**SUBJECT: Transmittal of Revised Responses to AP1000 DSER Open Items**

**AP1000 Design Certification Review  
Draft Safety Evaluation Report Open Item Non-Proprietary Responses**

DSER Open Item Number: 19.1.10.2-1 (Response Revision 1)

**DSER Open Item Number: 19.1.10.3-1 (Response Revision 2)**

Figure 45-39

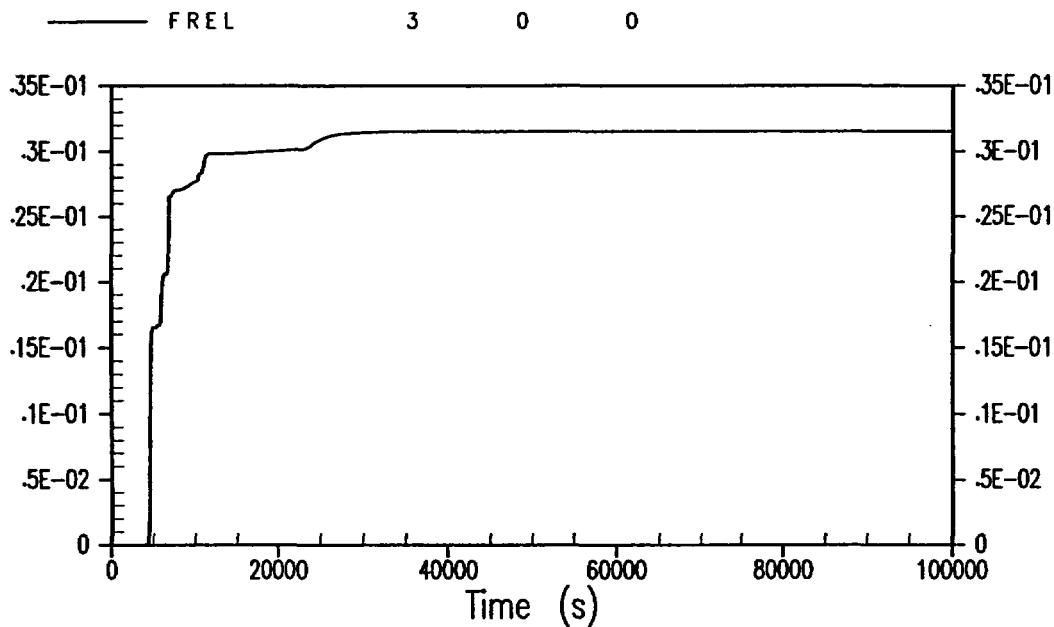
The Revision 1 response to this DSER Open Item included major revisions to Chapters 34 and 45 of the AP1000 PRA. In discussions with the staff, they indicated editorial mistakes with the revised PRA Chapter 45. These corrections will be incorporated in the PRA and are shown in the attached markup of Chapter 45.

Release Category CFE, Case ~~3D4~~ <sup>CFE</sup> – Spurious ADS-2, Failed CMTs,  
Diffusion Flame: Release Fraction of Tellurium Dioxide

Figure 45-40

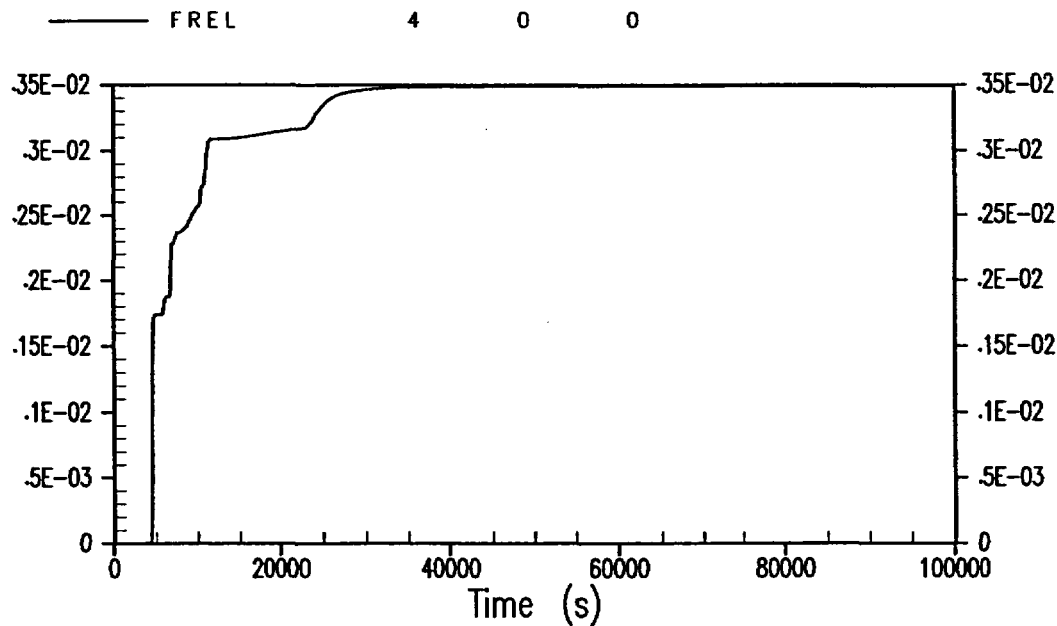
Release Category CFE, Case ~~3D4~~ <sup>CFE</sup> – Spurious ADS-2, Failed CMTs,  
Diffusion Flame: Release Fraction of Strontium Oxide

Figure 45-47

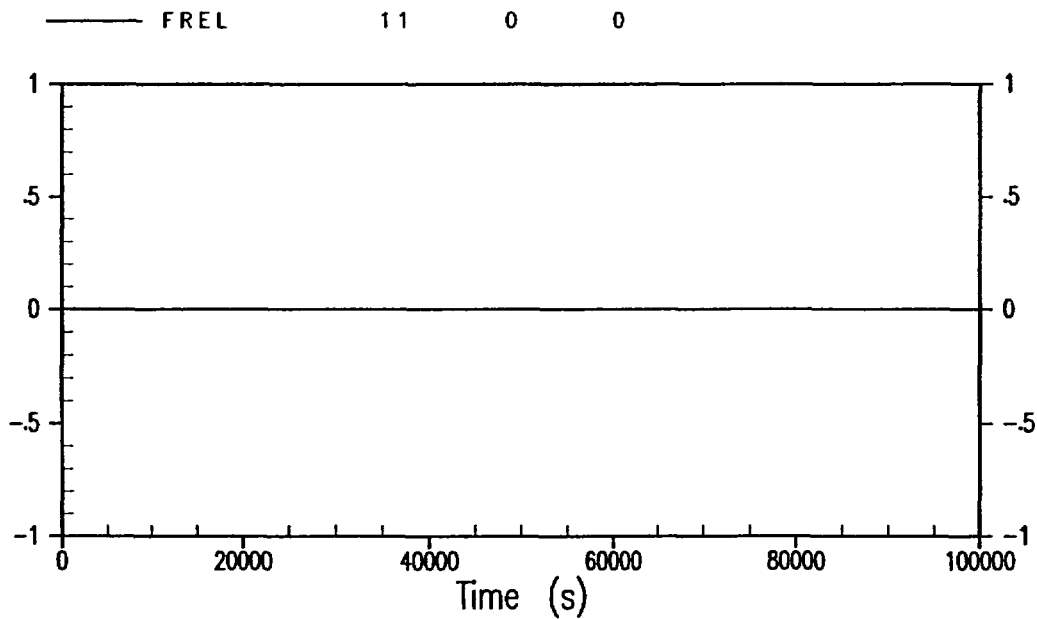
Release Category CFE, Case <sup>CFE</sup>3D-4 – Spurious ADS-2, Failed CMTs,  
Diffusion Flame: Release Fraction of Tellurium

Figure 45-48

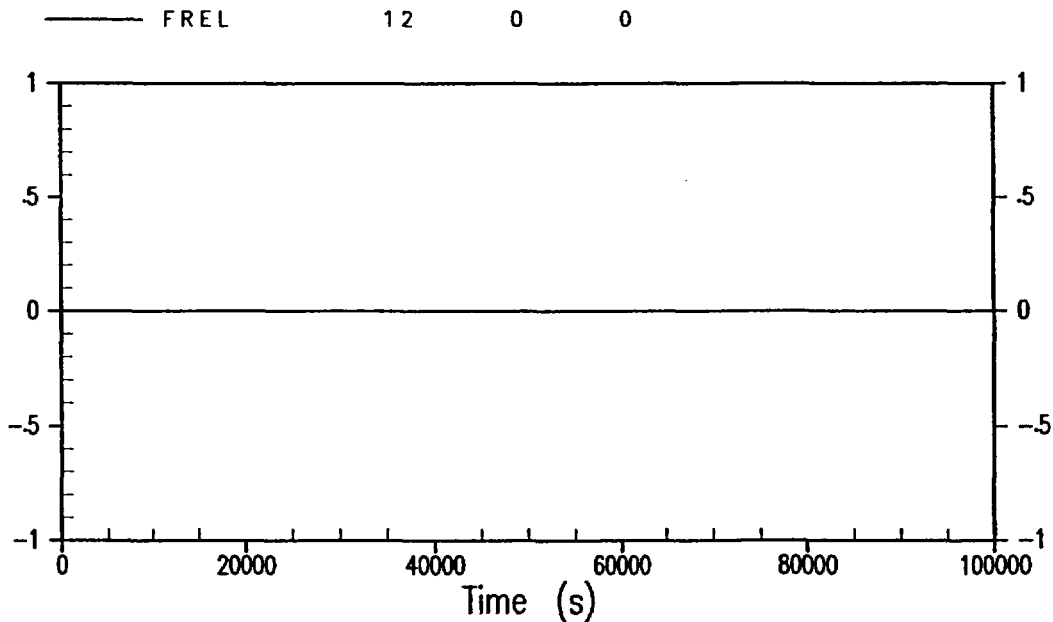
Release Category CFE, Case <sup>CFE</sup>3D-4 – Spurious ADS-2, Failed CMTs,  
Diffusion Flame: Release Fraction of Uranium Dioxide
